Design Review Board Meeting

Tuesday, January 14, 2025, 2:30 PM

**San MIGUELS Bar
9 Harbourside Lane
Shelter Cove Marina
Final Submittal
January 14, 2025
DRB-000008-2025**

**San Miguel Bar
9 Harbourside Lane
Shelter Cove Marina
Plan Set
January 14, 2025
DRB-000008-2025**

BAR SECTION
SCALE: 1/4" = 1'-0"

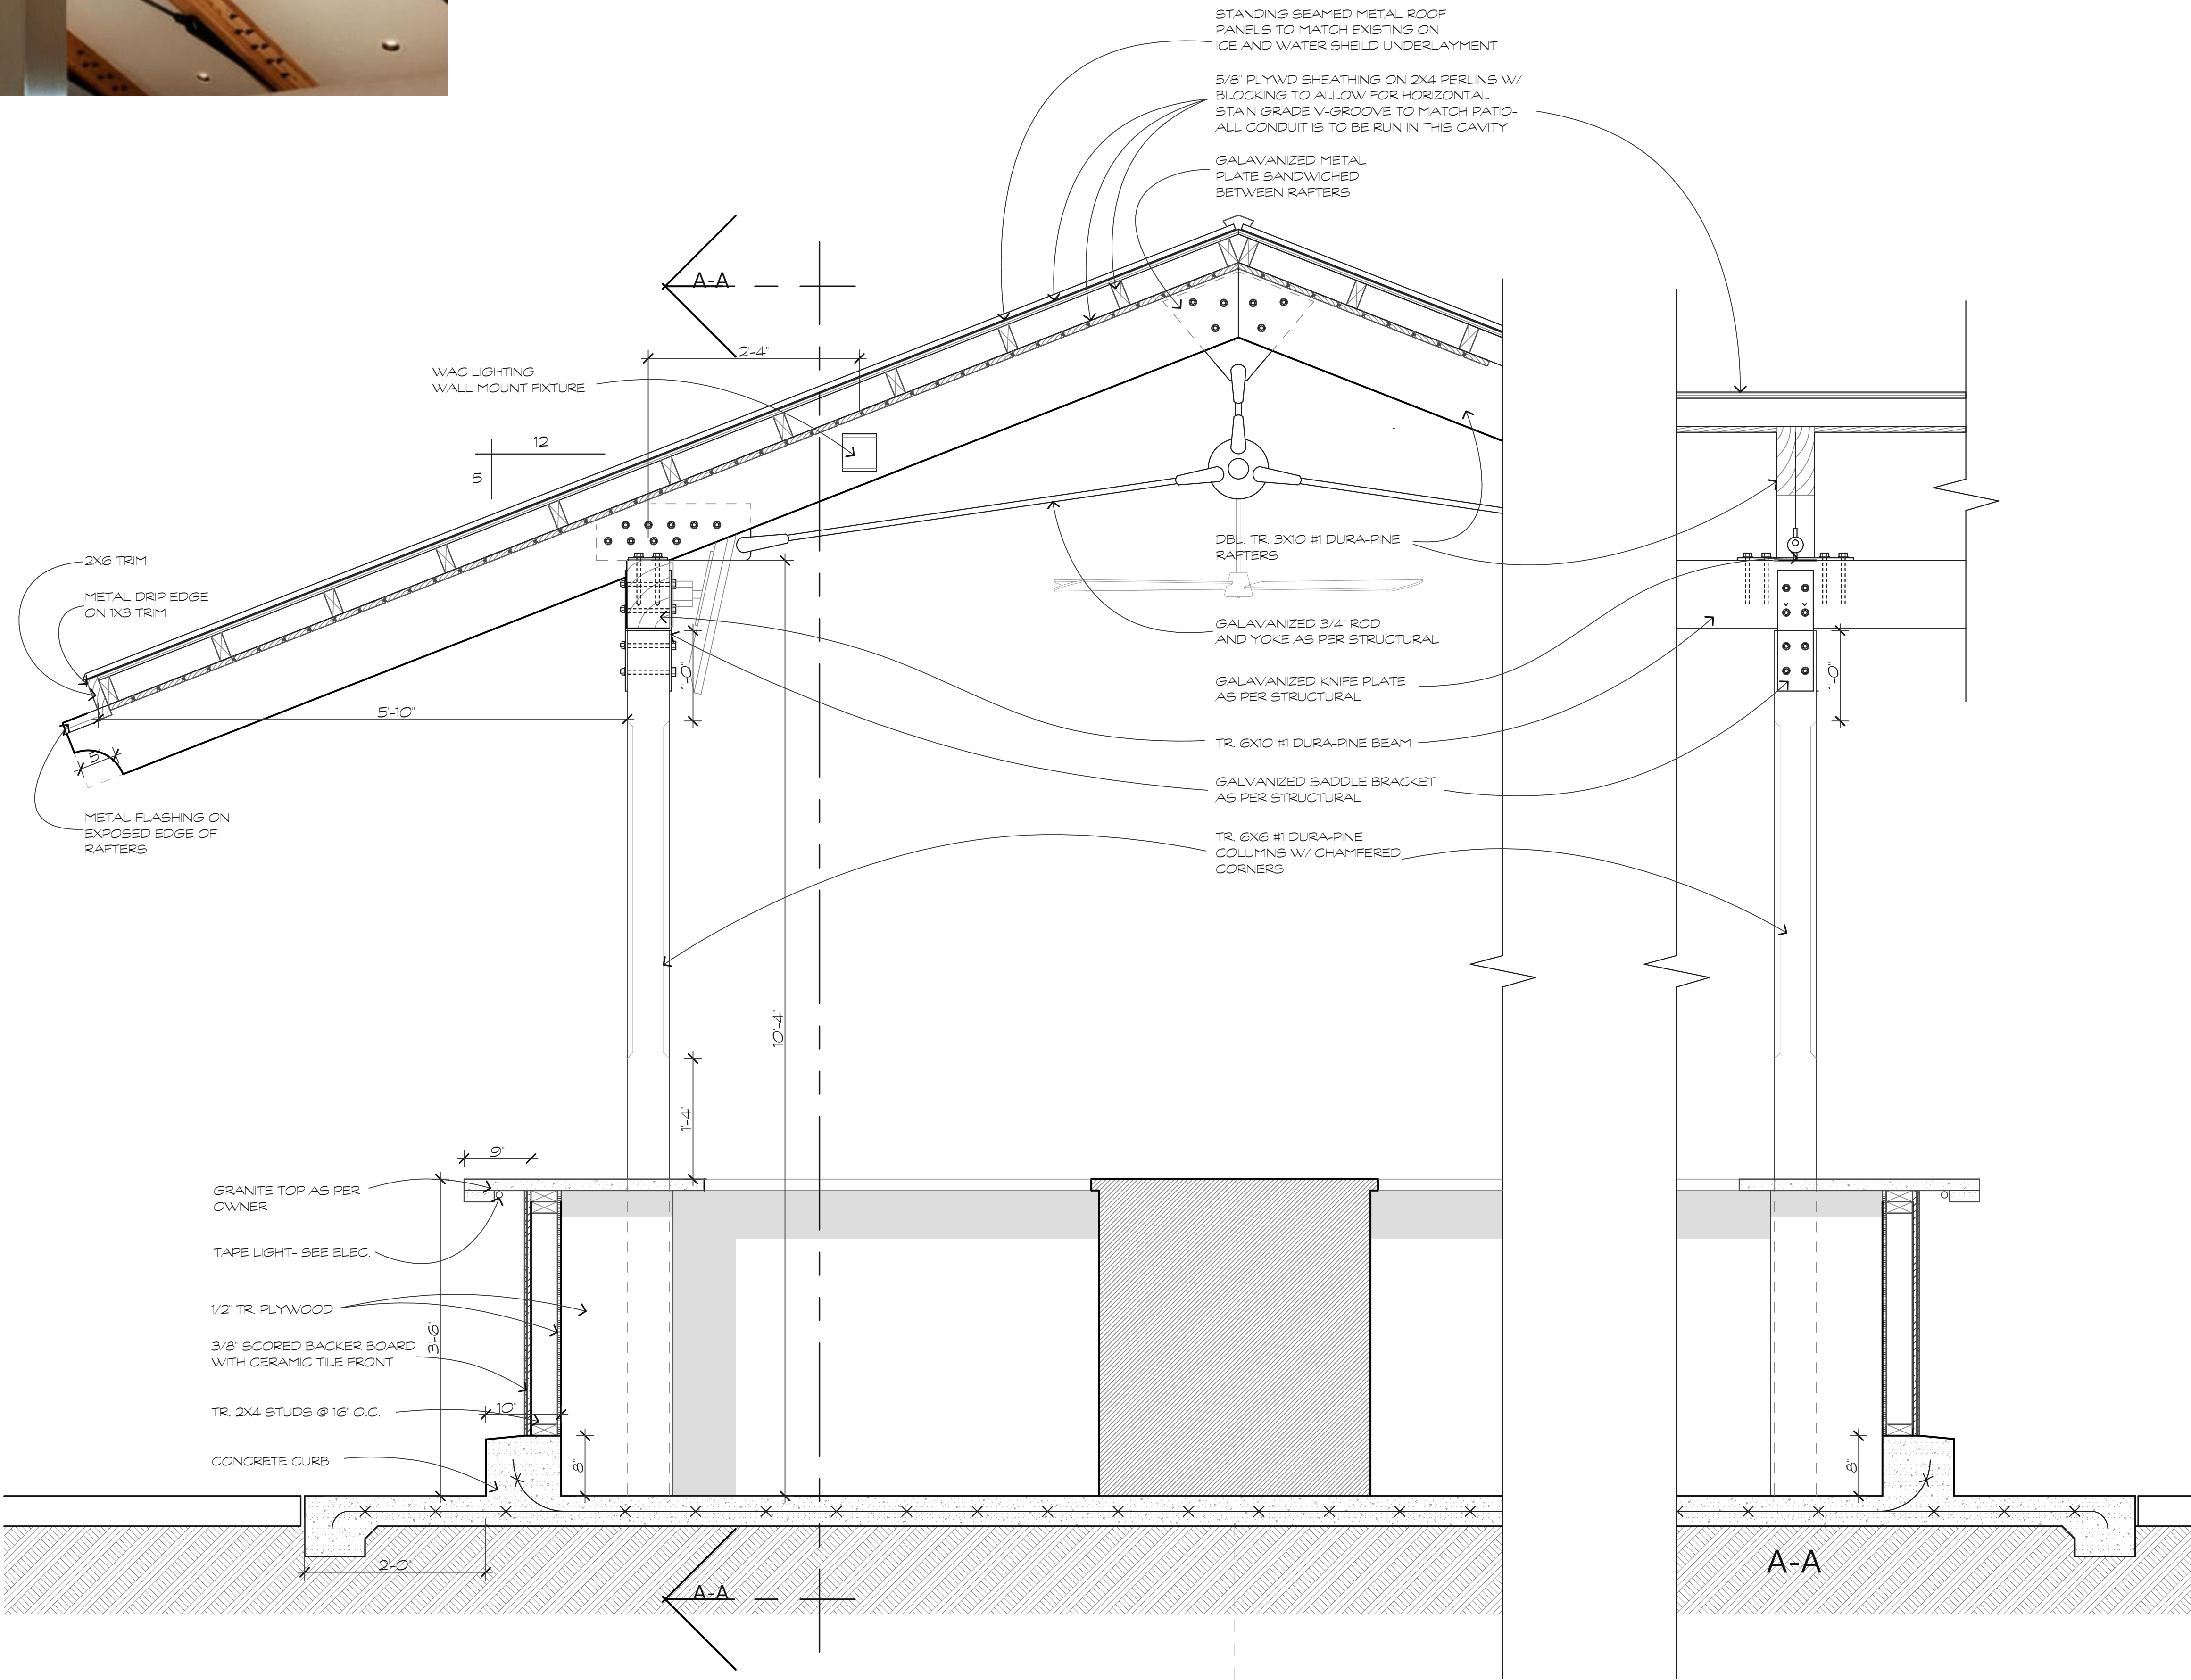
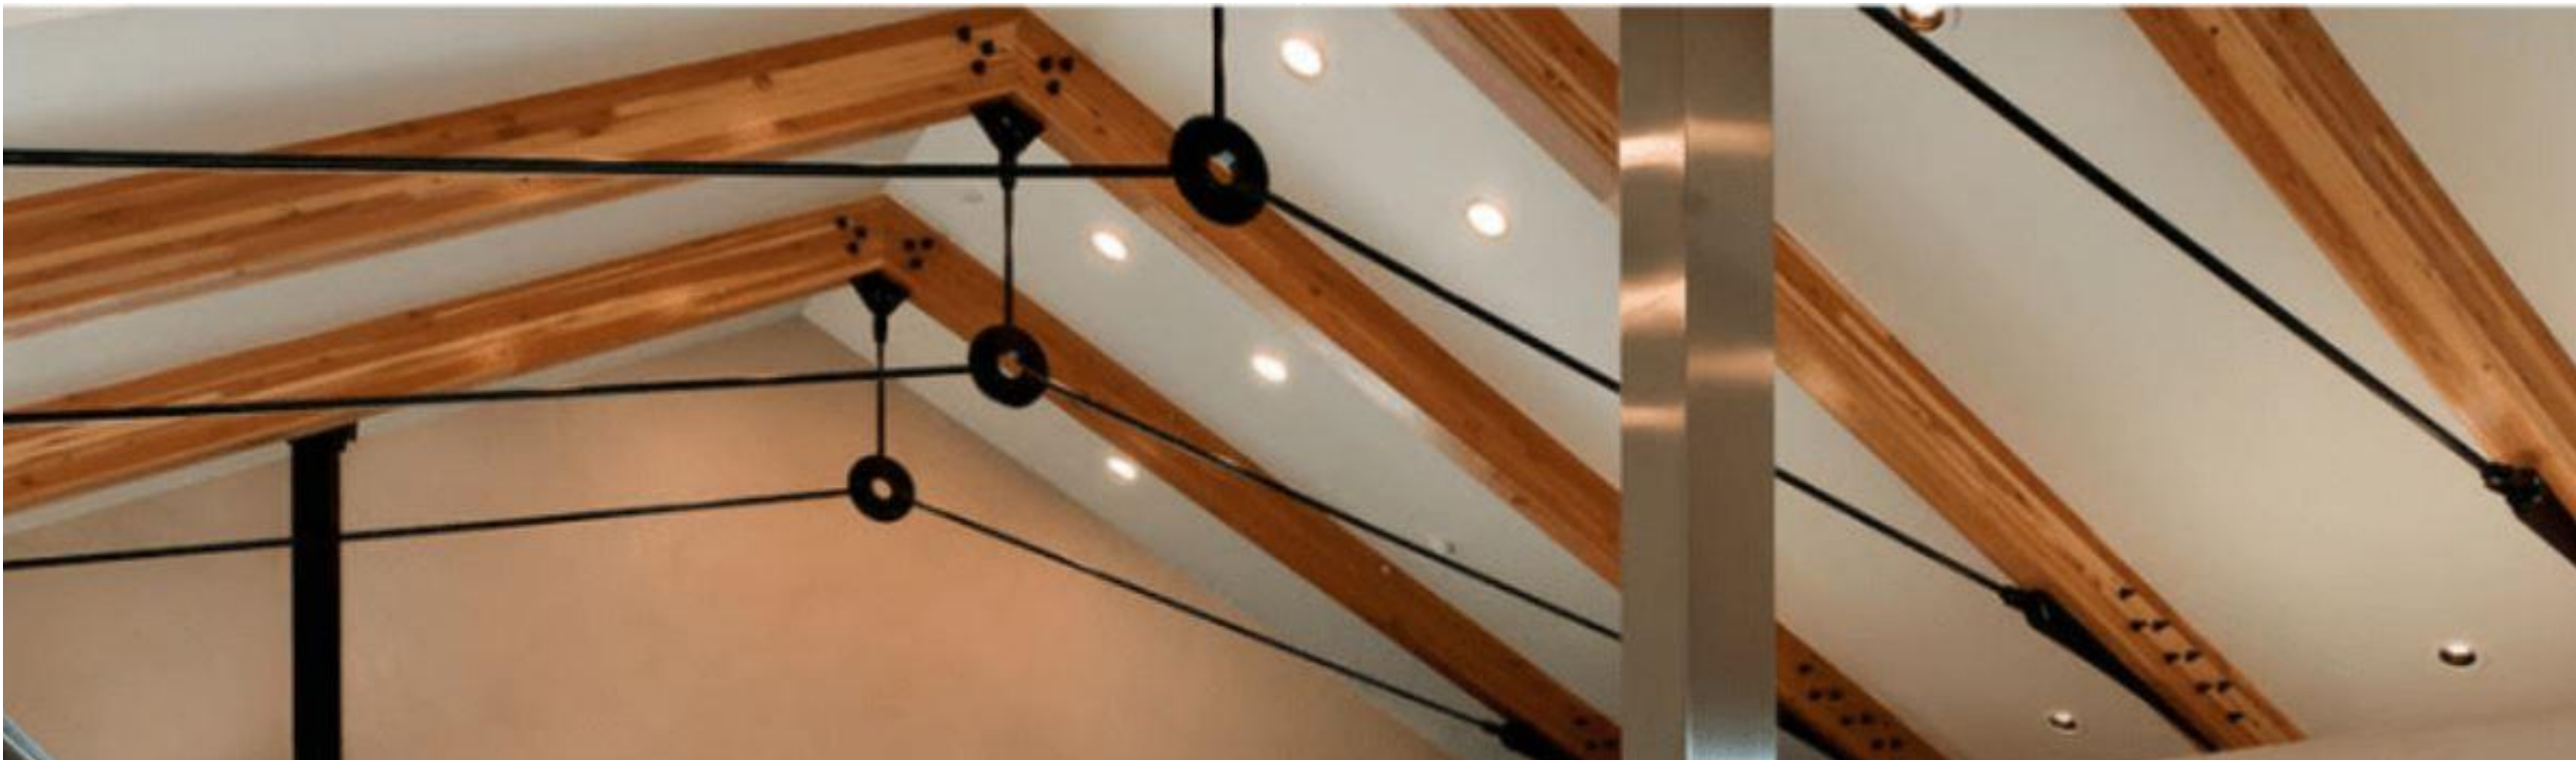
1. Staff recommends approval of the final review of the San Miguel Bar submittal with the following conditions:
2. Per Fire & Rescue Department - Provide clearance to combustibles on Sheet A.3 from gas heaters. Specs provided only give clearance for 0-degree mounted options when the drawing shows the 30-degree option. Need further clarification.
3. The lighting Plan / photometrics indicates there are four lights ranging from 46.4 to 48.7 lumens. Make sure those four lights are shielded.
4. Any additional information as required by the Board.

DRAWING NO:
EP-100

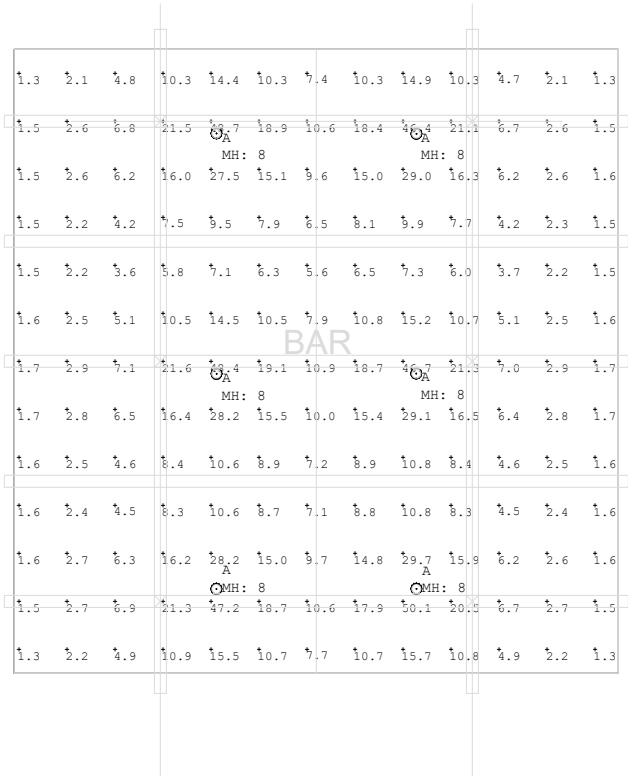
3. Specify locations of the string lights. *We have noted the existing and new locations of the string lights on the plans.*
4. Indicate the LED light levels at the countertop. *We are providing a photometric drawing with this submittal.*

BMH EMERGENCY & URGENT CARE CONCEPTUAL SKETCHES - ARCHITECTURAL CHARACTER

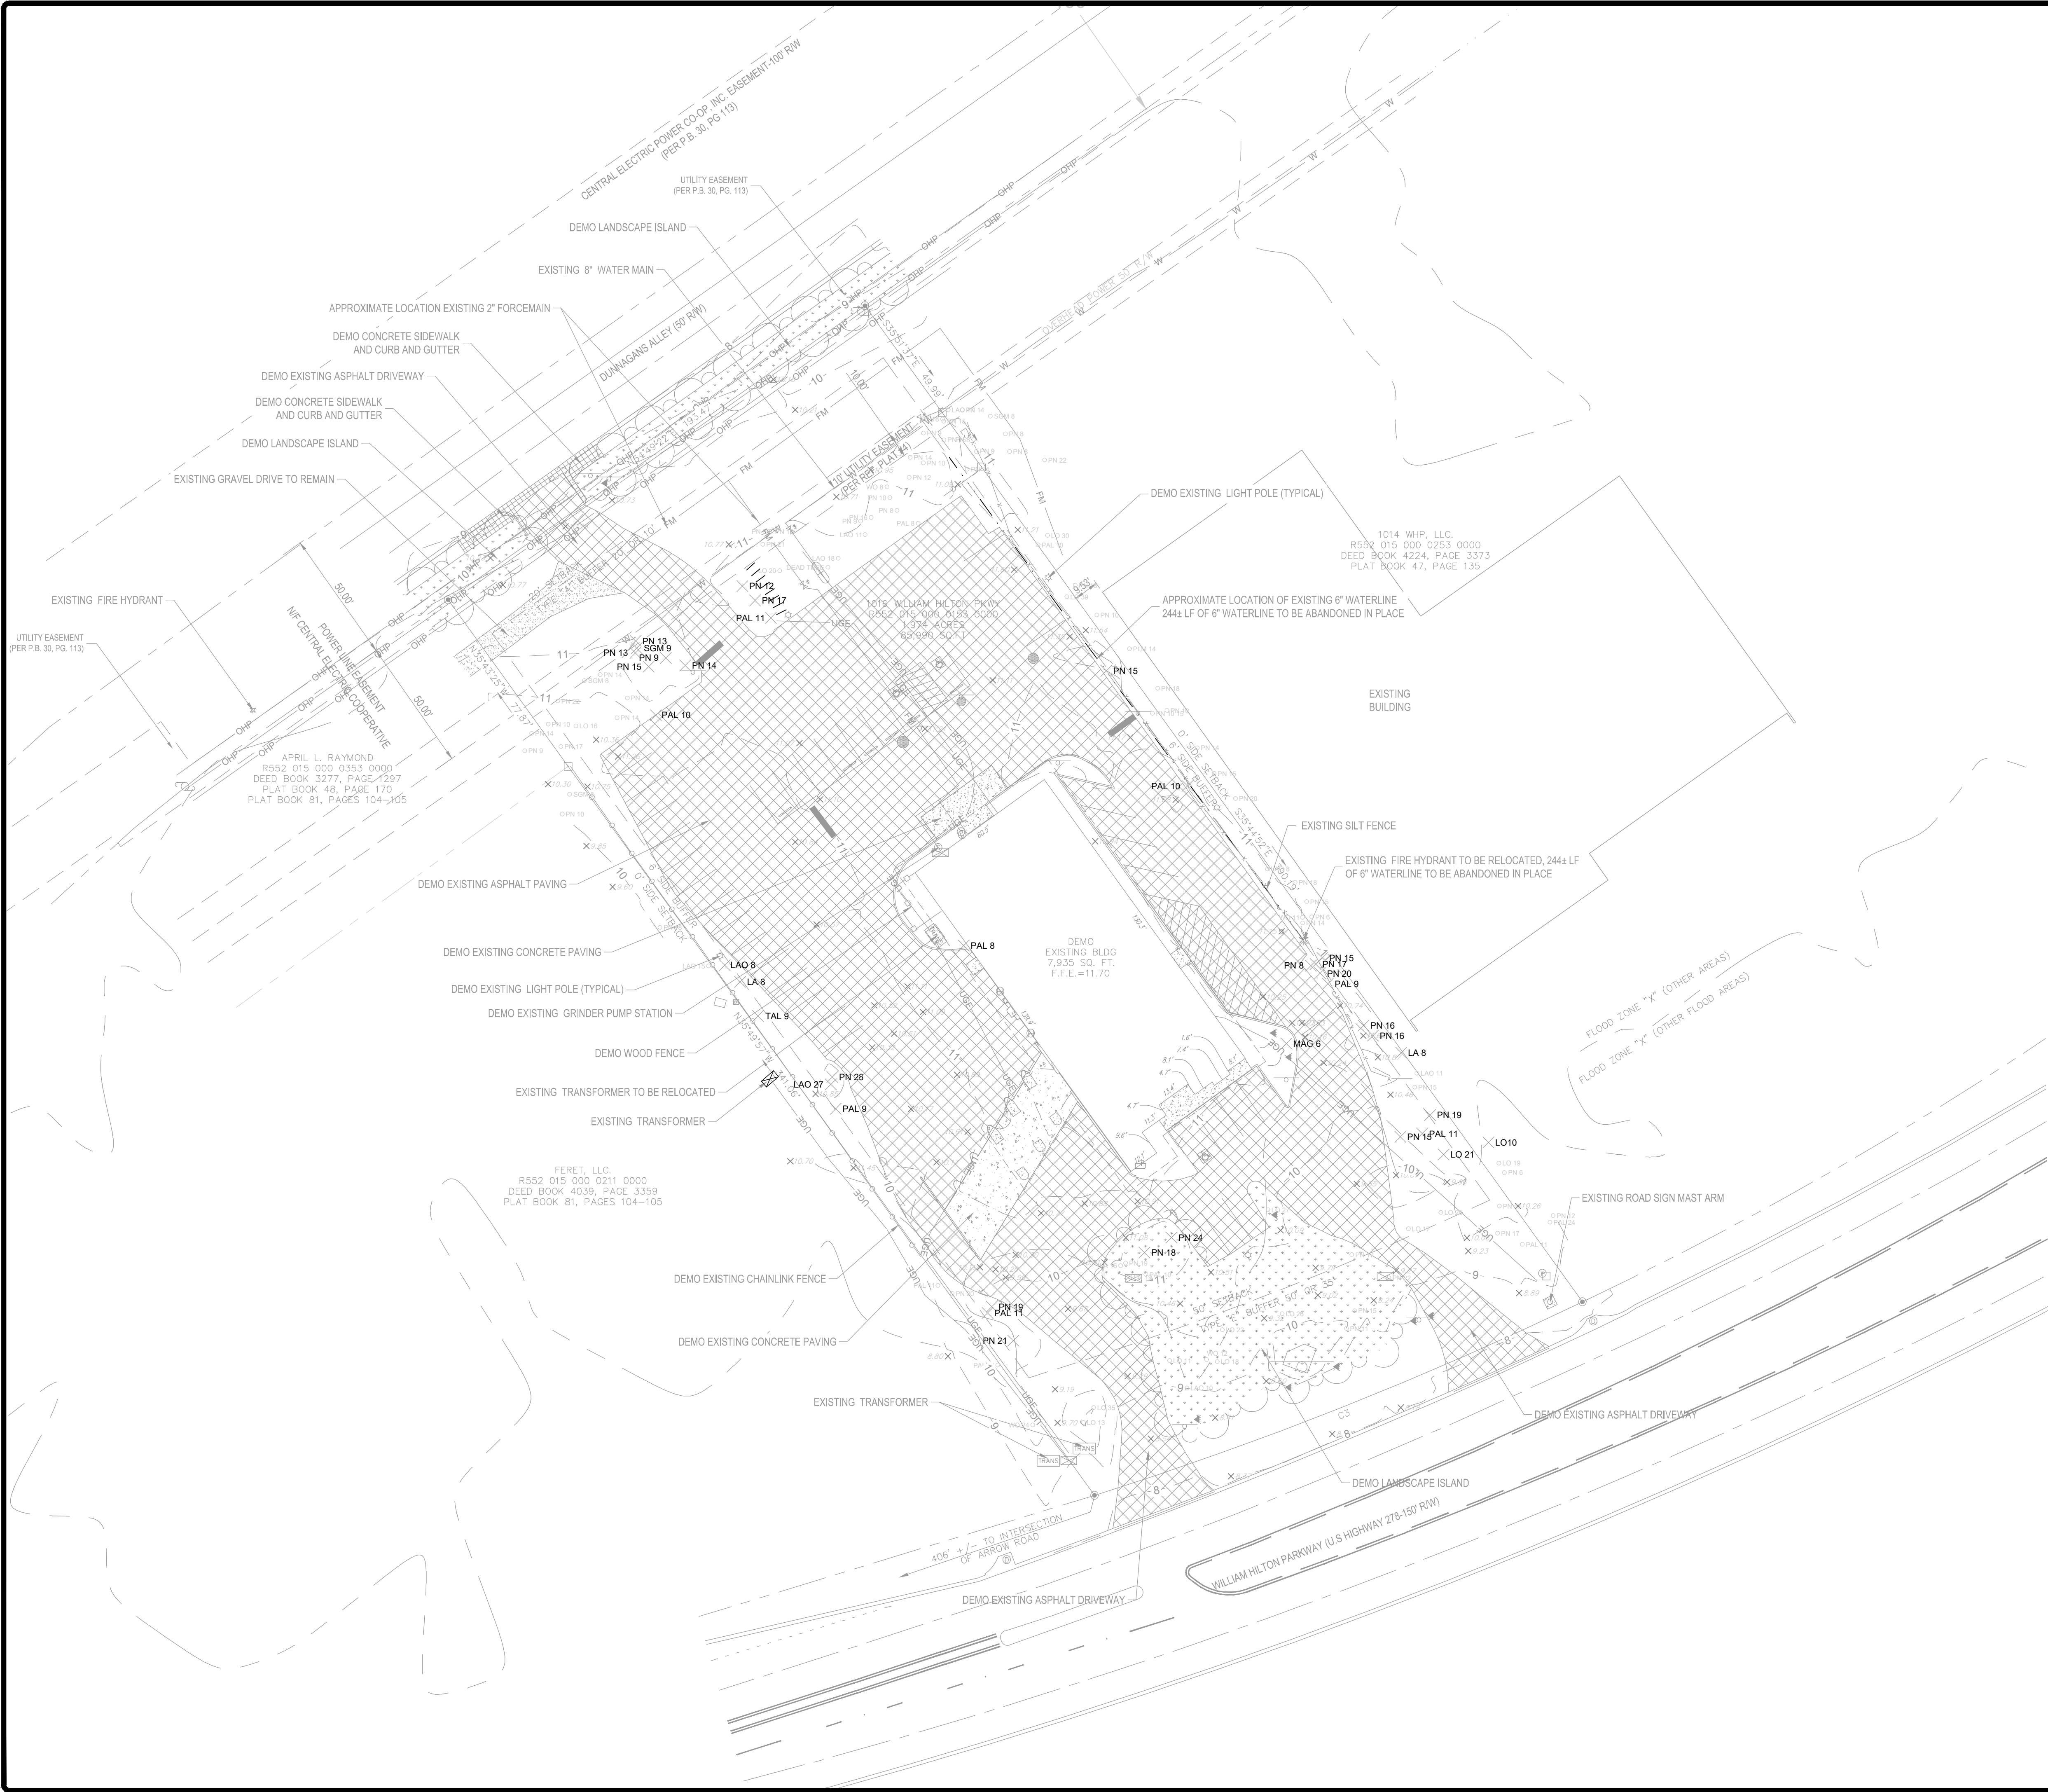
| <ol style="list-style-type: none">5. Provide a Roof Plan.6. Indicate in the elevations the proposed materials.7. Provide an exterior Lighting Plan.8. Any additional conditions provided by the Board. |
